EVOLVE BLOOMINGTON
BUILDING 100 & 200
N DUNN STREET & E 17TH STREET
BLOOMINGTON, IN, 47408
CA / REGENCY DUNNHILL JV, LLC

**BLOOMINGTON PLAN COMMISSION
STAFF REPORT**

REQUEST: The petitioner is requesting site plan approval for two four-story mixed use buildings. The petitioner is requesting a use variance approval to allow a 'drive-through' use within a Commercial Downtown (CD) zoning district. The use variance request requires Plan Commission review of compliance with the Growth Policies Plan.

Cityside 123 LLC
CITYSIDE
Bloomington, Indiana

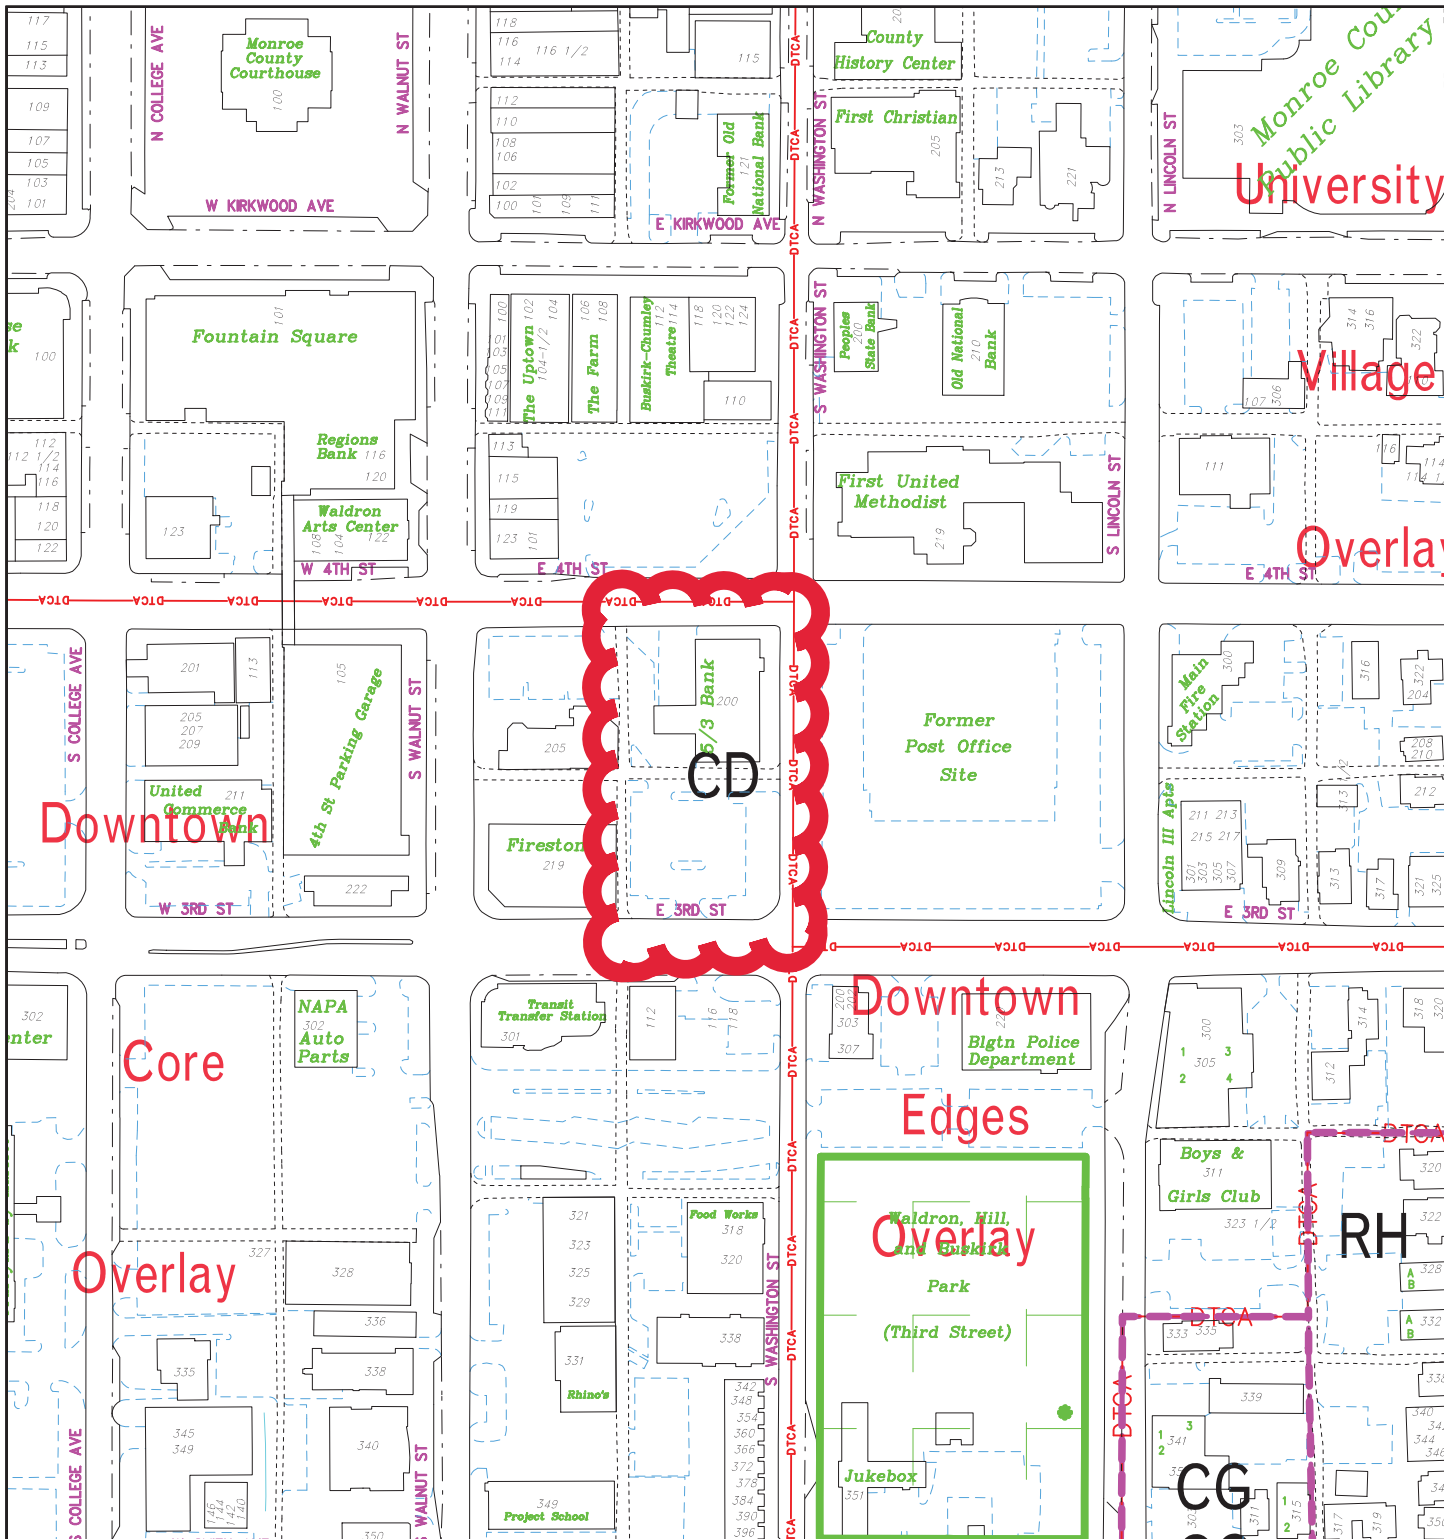
Façade materials The existing bank building (building number 2) incorporates limestone in its facade. Limestone is not only beautiful, but it's a local product that the EC encourages using. The addition of buildings number 1 and 3 should also use local limestone rather than concrete simulated to vaguely look like limestone, because "architectural cast stone", which is concrete, carries a large environmental footprint.

Solar panels This building is ideal for photovoltaic (PV) solar panels because it has a flat roof. The price of PV systems continues to drop and the full-cost-accounting price of carbon-based electricity is skyrocketing.
